Tippecanoe County Board of Commissioners

Meeting
Monday, May 4, 2020
10:00 am
Tippecanoe Room, Tippecanoe County Office Building
20 N 3rd Street, Lafayette, Indiana

VIII. 4 CHANGE ORDERS & 1 AGREEMENT FOR FAIRGROUNDS PROJECT

PROJECT *(Name and address)*:
885-Fairground Renovations
1406 Teal Rd.
Lafayette, IN 47905

Date 3/12/20 Project 885 - COLISEUM Sheet #

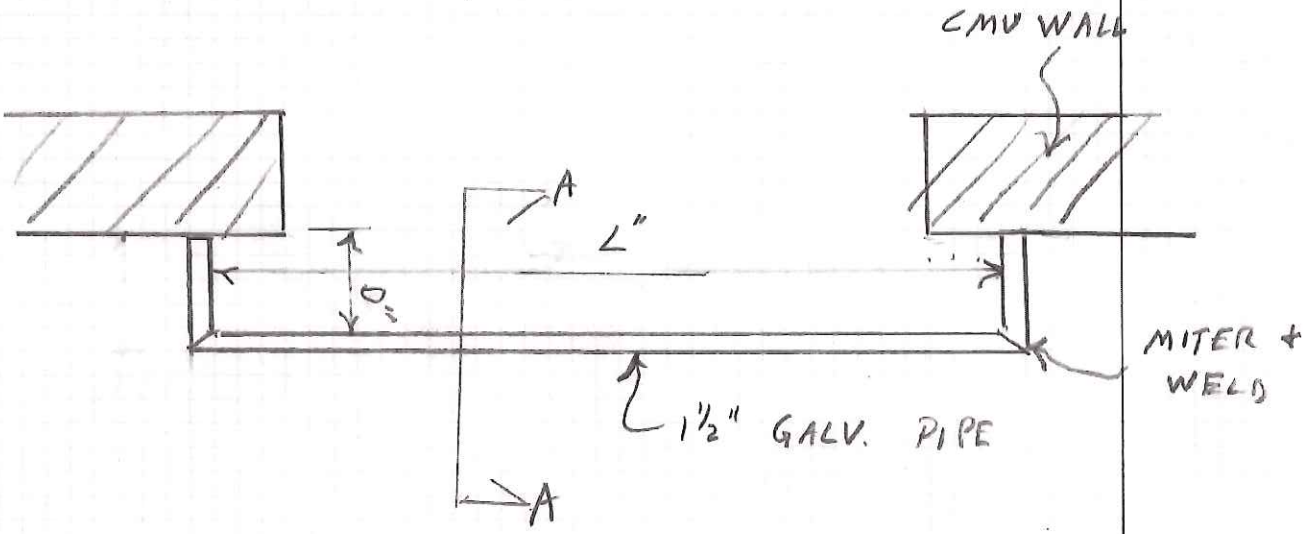
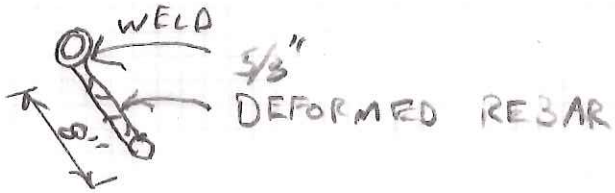
EWO 885-084

[] Add slab-on-grade 3/4" depression embeds at 6 ea. exterior overhead doors per attached detail.

@ OVERHEAD DOORS 106D, 119E - 126D

L = 24'-8"

D = 7"

@ OVERHEAD DOORS 124C, 125C + 126C, 137D, and 137C

L = 12'-8"

D = 6"
